Site Address: 42 High Street, Emsworth, PO10 7AW

Proposed Development: Replacement shop front and signage following the withdrawal of Planning Applications APP/11/00957 and APP/11/01015.

DRAWING 2 FROM CONSERVATION OFFICE
FOR ADVICE TO APPLICANT

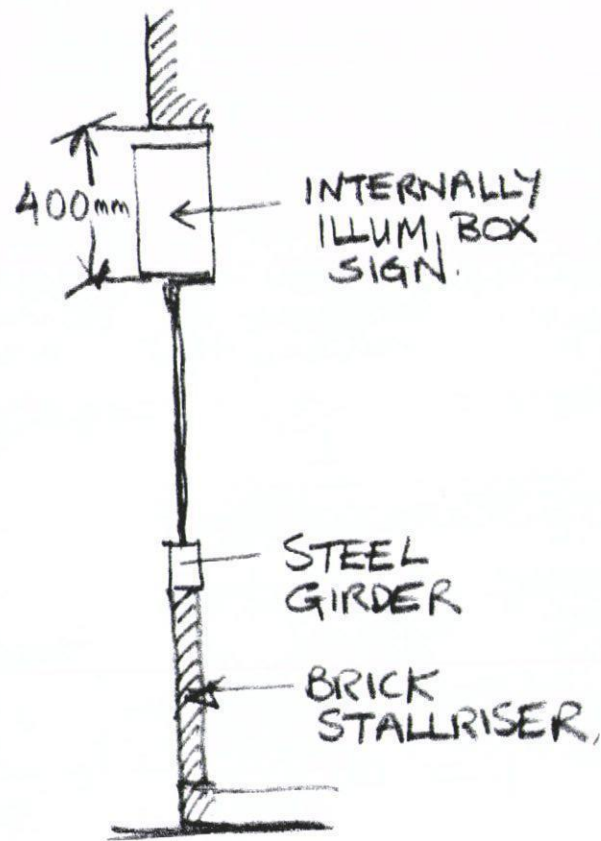
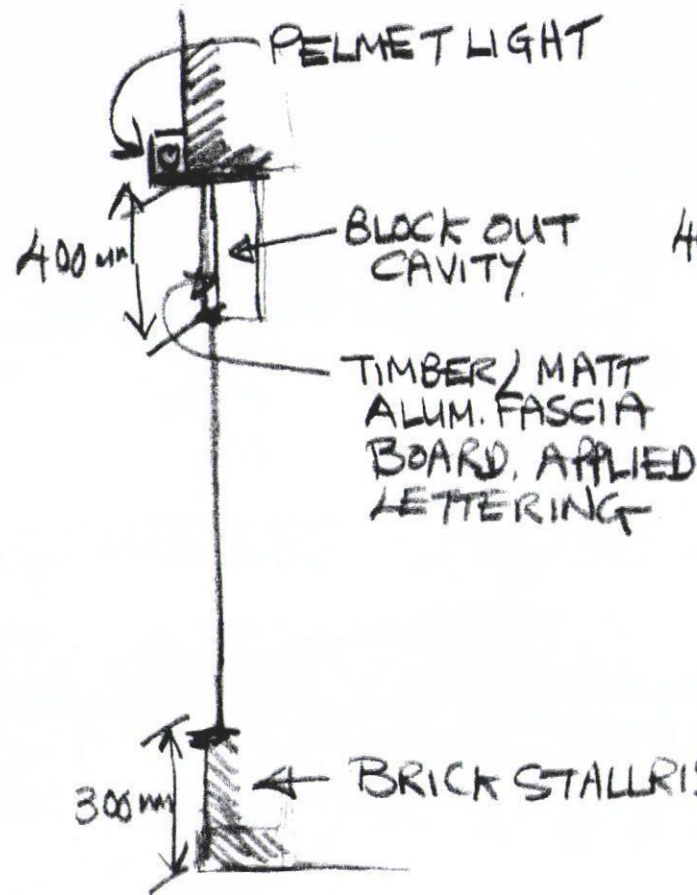
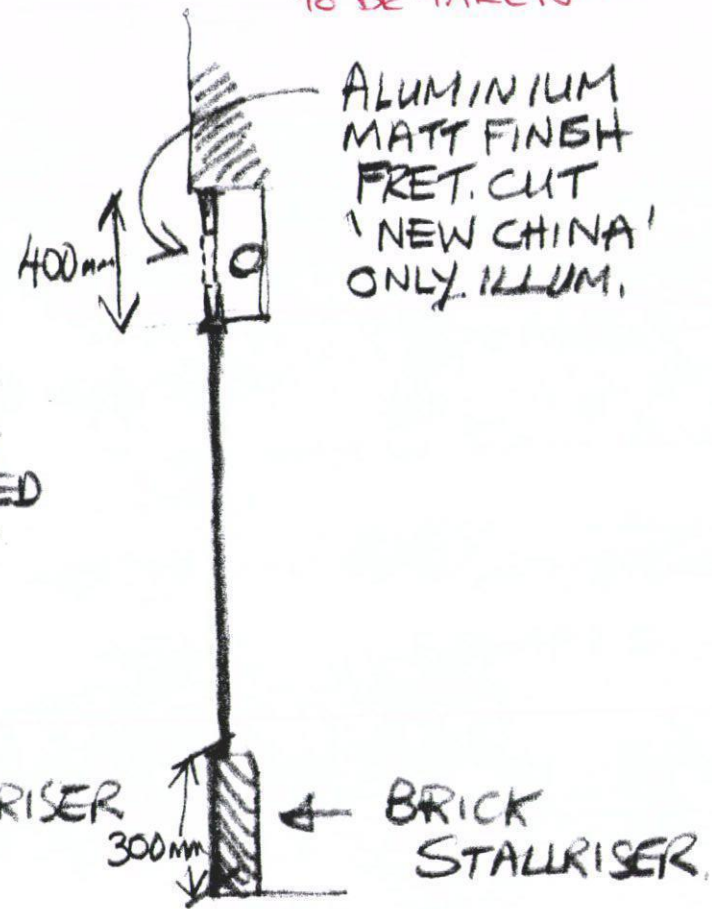
2. I would suggest the sign and shopfront are updated. It is your choice. Either way the two need to be considered together.
3. **Sign.** The depth of the present internally illuminated box is 400mm. This is proportional to the building, shopfront and other shops in the vicinity. I can not support increasing its depth to 600mm. However, there are a number of choices in the way the current sign can be adapted / improved. These are:-

- a. Remove the existing unit completely. Replace with a new sign and fascia set flush or slightly recessed to the adjacent masonry. Fascia material preferably painted timber with applied lettering, but alternatives such as aluminium with matt finish can be considered. External illumination using continuous pelmet light of the form illustrated on dwg.no NC001. No other form of illumination.

- b. Remove existing unit completely. Replace with new sign with fascia set flush or slightly recessed to the adjacent masonry. Aluminium fascia (matt finish) with fret cut lettering 'New China' only back lit. No other form of illumination.

- c. Refurbish existing internally illuminated sign. Replace front perspex panel with aluminium design as per b. above. This is the least satisfactory of the solutions but may address your concerns over cost.

OPTION 1
SUBTLE EXT. ILLUM
IN FORM OF CONT.
PELMET

OPTION 2.
INT. ILLUM
'NEW CHINA'
LETTERS ONLY.

OPTION 2
TO BE TAKEN.

DRAWING 1 FROM CONSERVATION OFFICE
FOR ADVICE TO APPLICANT

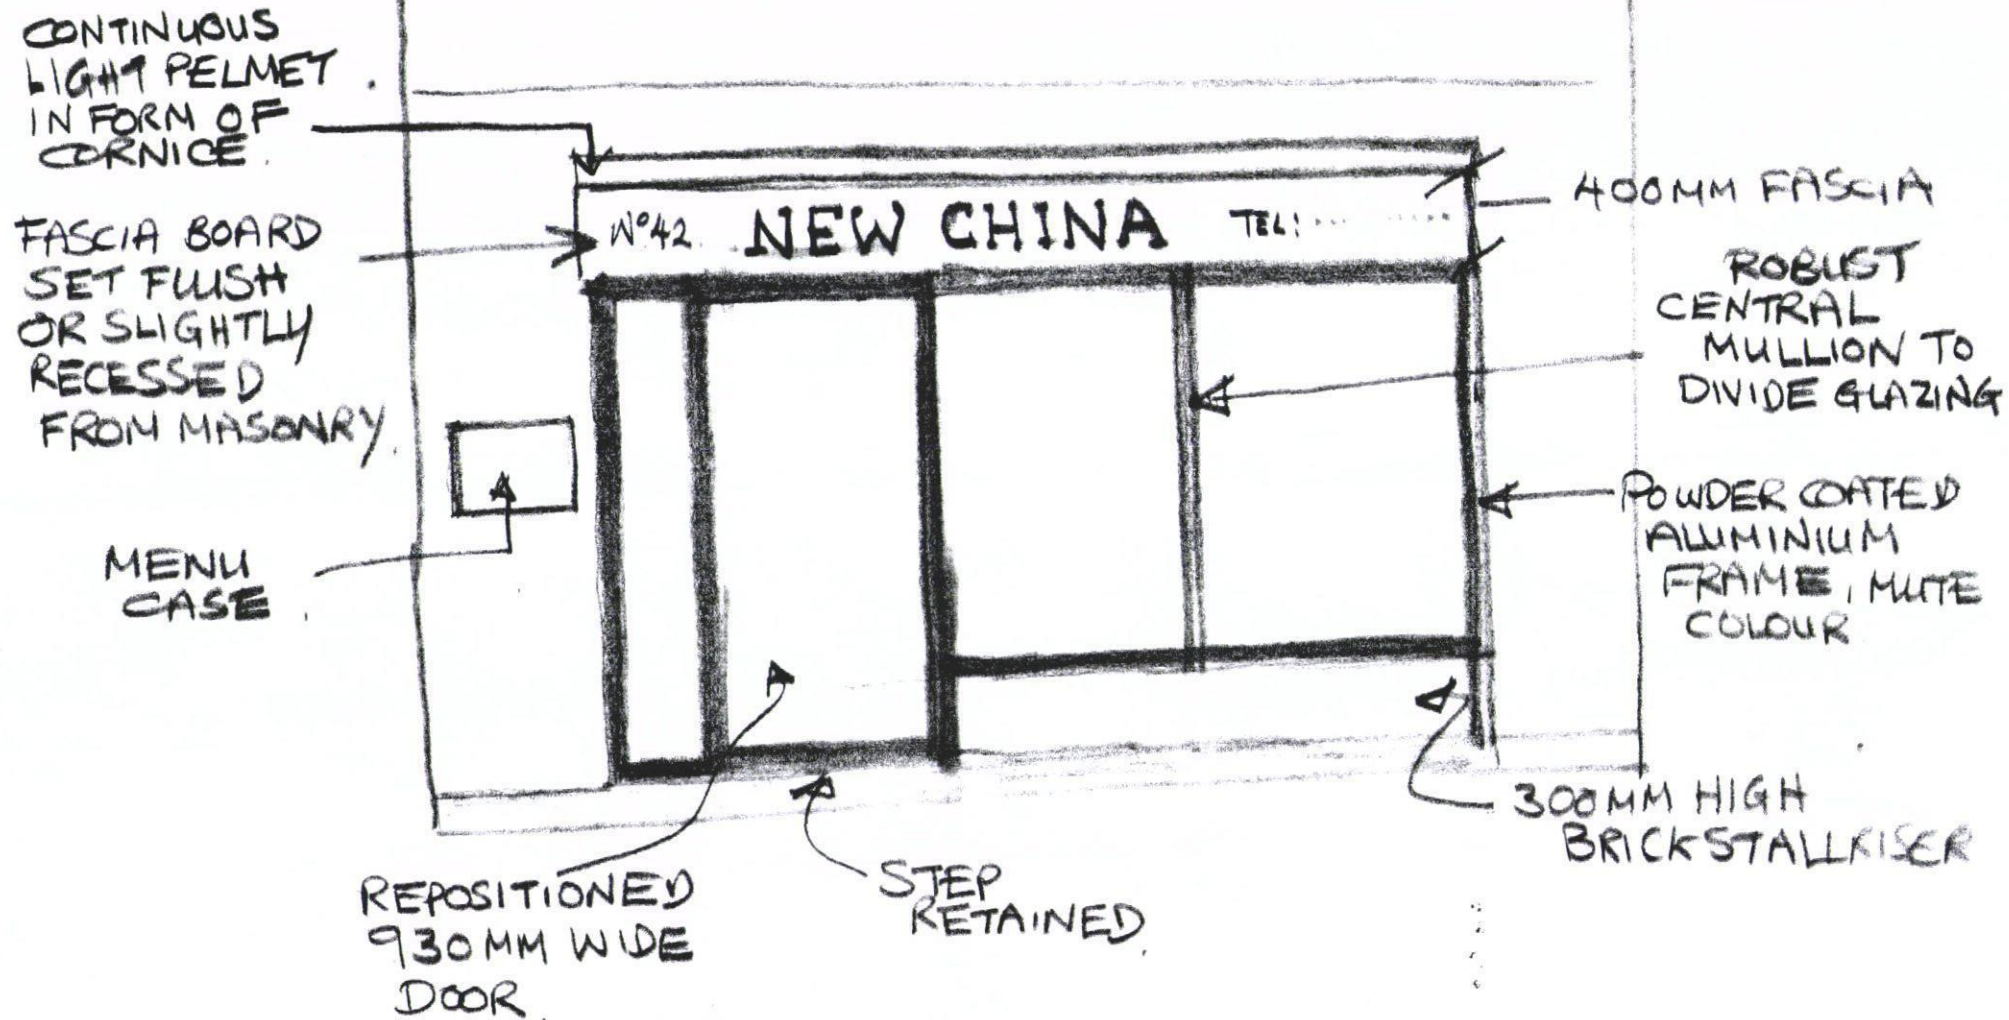
4. **Shopfront.** Subject to modifying the fascia to accord with the current depth of 400mm, the approach to the design of the shopfront with a larger area of plate glass sub-divided vertically with a 300mm brick stall riser is broadly acceptable. If the application is to be progressed to application stage, the drawings will need to be embellished to include a full elevation of the building so that the shopfront is seen in context. Likewise details of the

Illustration to show form of new shopfront & fascia sign
